INSTRUCTIONS TO PERFORM CAMPAIGN 129

This campaign affects 2011 model year E30W Winnebago® Vista® and Itasca® Sunstar®.

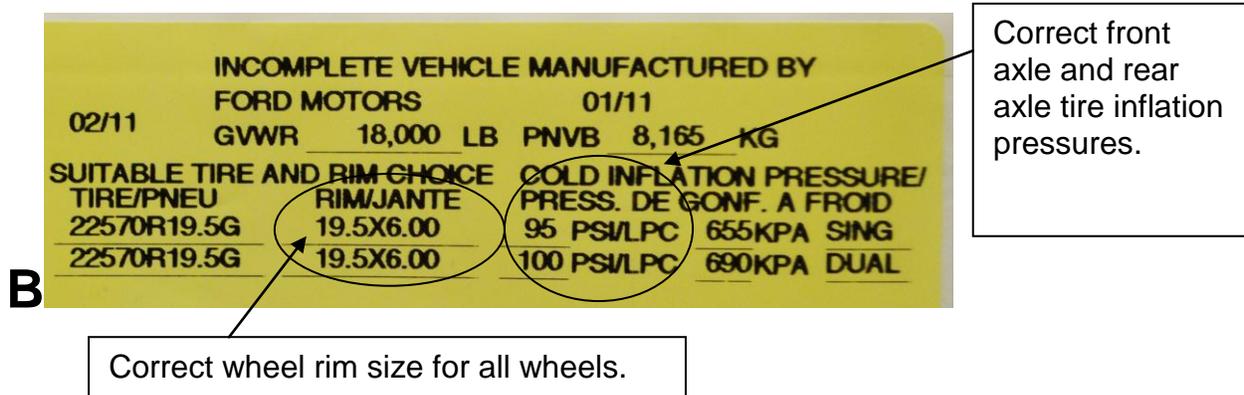
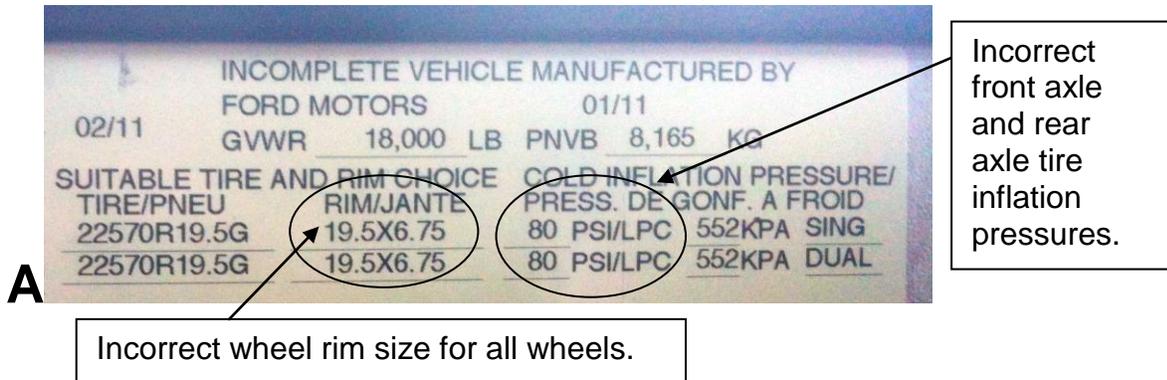
The affected vehicles were produced with a Vehicle Certification Label that incorrectly states the tire inflation pressures and wheel size. Incorrect labels will be replaced with correct ones.

The incorrect labels identify the front axle and rear axle tire inflation pressures as 80 PSI and wheel rim size as 19.5x6.75. See Photo A. The correct front axle tire inflation pressure is 95 PSI and rear axle rear axle tire inflation pressure is 100 PSI. The correct wheel rim size is 19.5x6.00 for all wheels. See Photo B.

Install Label

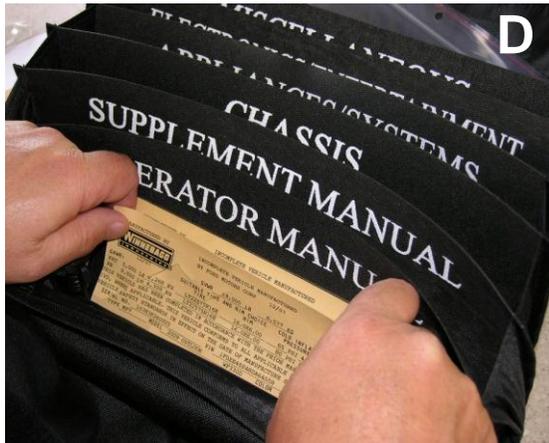
1. Cover the existing Vehicle Certification Label below the driver's window with the corrected label included with this campaign as shown in Photo C.
